City of Miami Beach
Last Completed Item Reviews Across All Submittals

Permit Type: Building - Commercial **Work Class:** Alteration (w/o Phased) **Application Date:** 05/22/2020 **Status:** Approved
Address: 235 WASHINGTON AVE **Permit:** BC2013662

Re: Response to City Comments.

Sobe Hostel
235 Washington Ave.
Miami Beach, Florida

1 LIFE SAFETY PLAN LEVEL 1 & 2

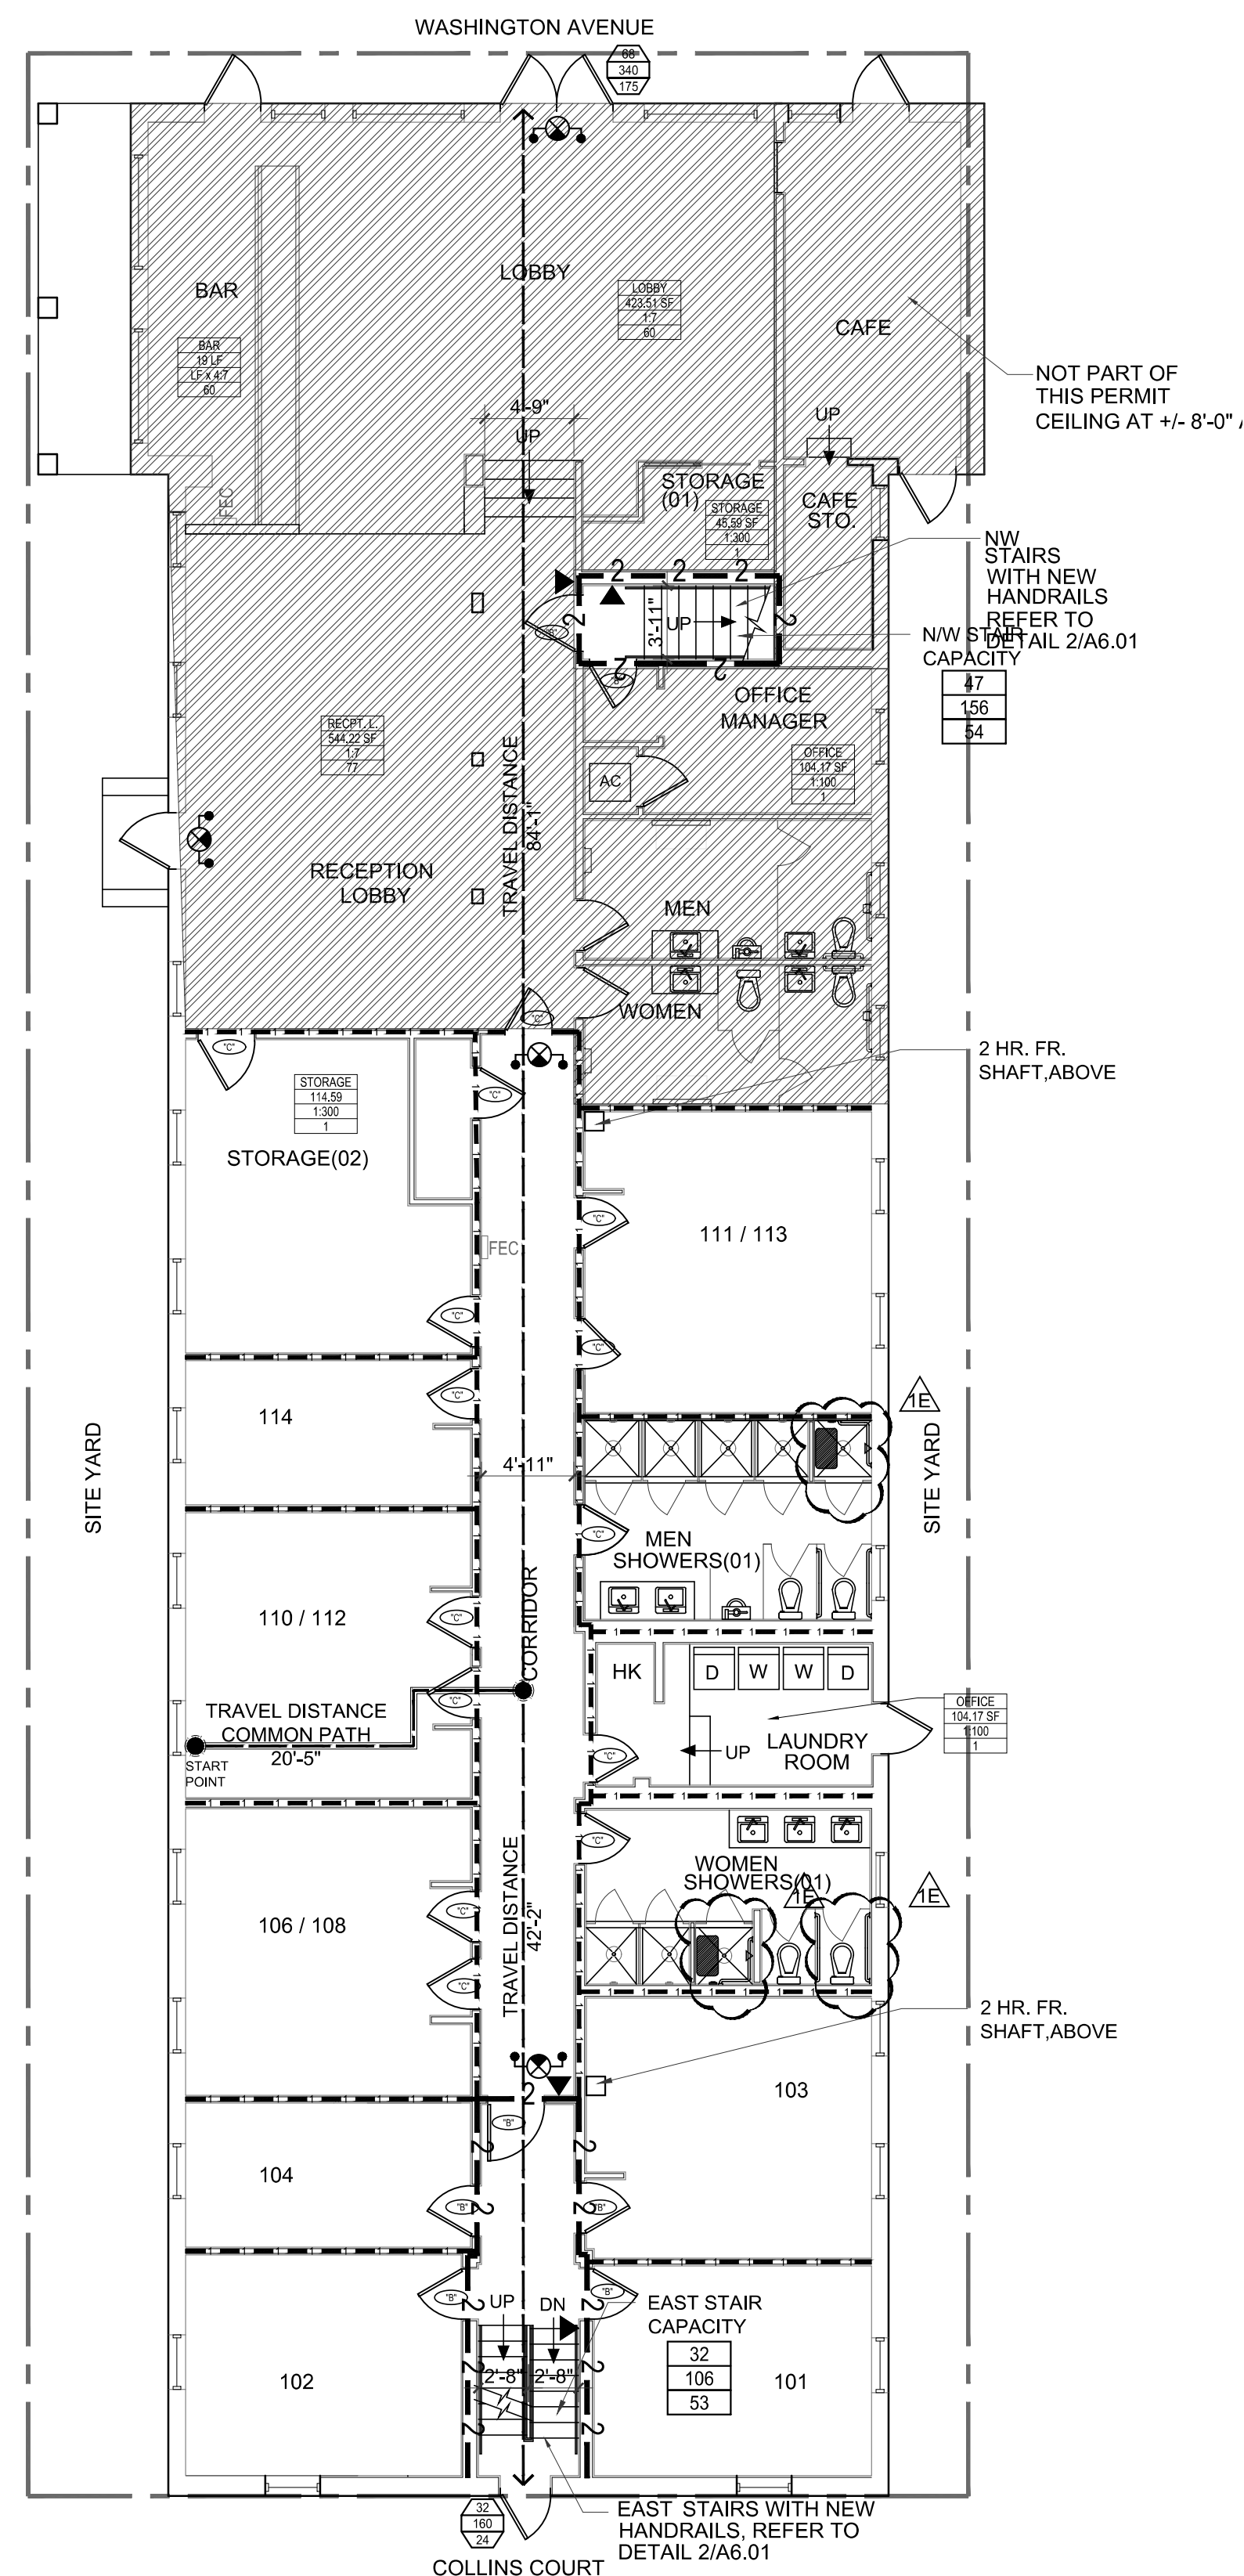
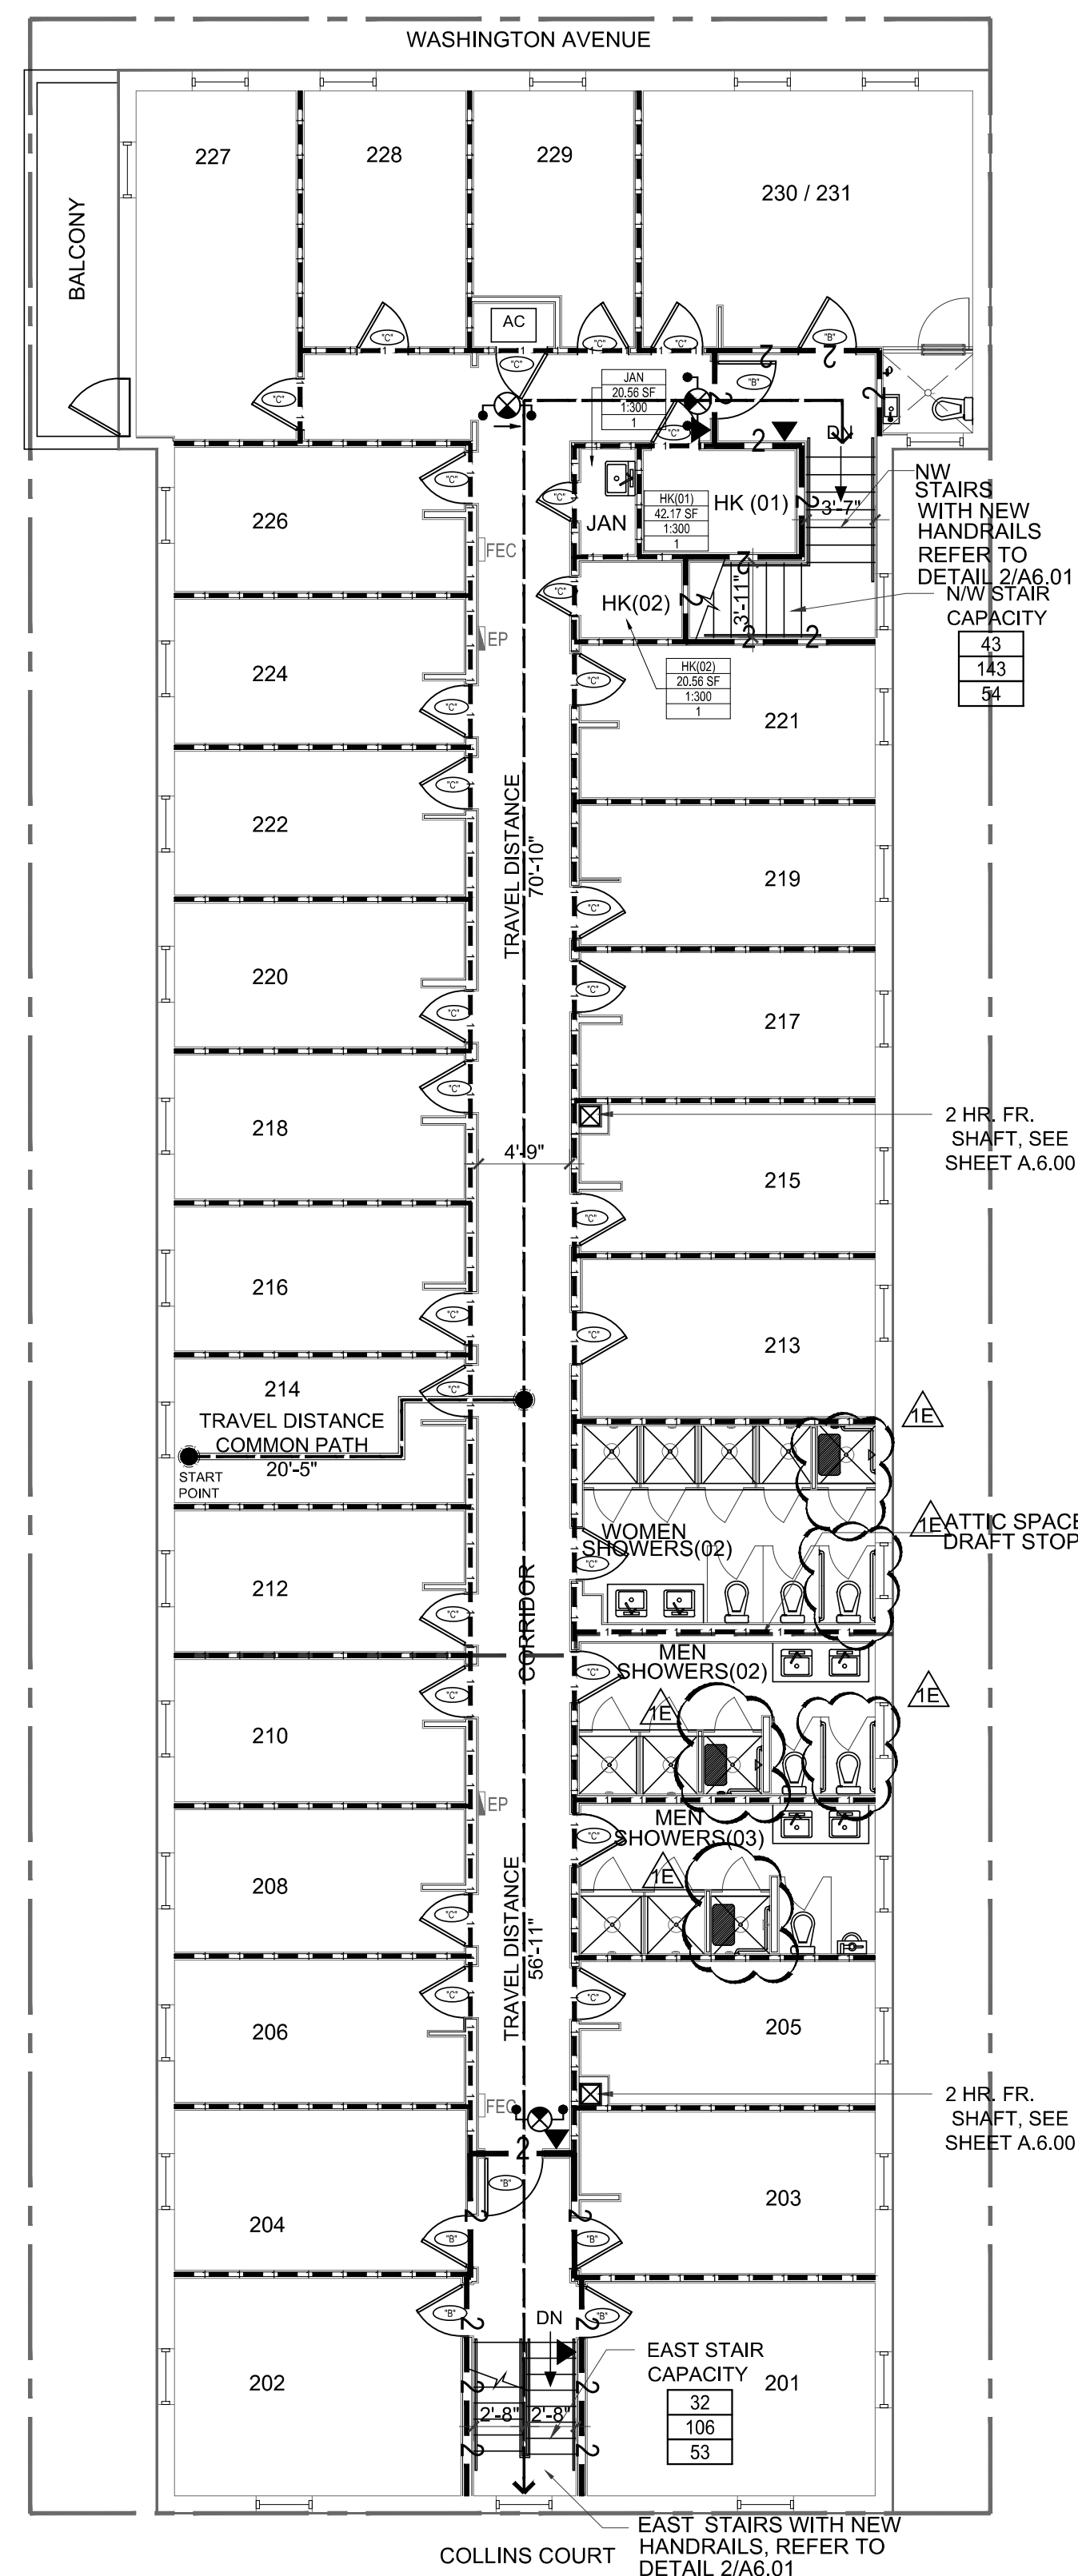
1. Provide the rating of the exit stairs to verify compliance with the ffpc 6th ed

KKAID Response: Refer to Life-Safety sheet A2.00 for identification of the fire rated partitions (existing and proposed). This sheet is only the Proposed Floor Plan showing dimensions and wall tags of new partitions
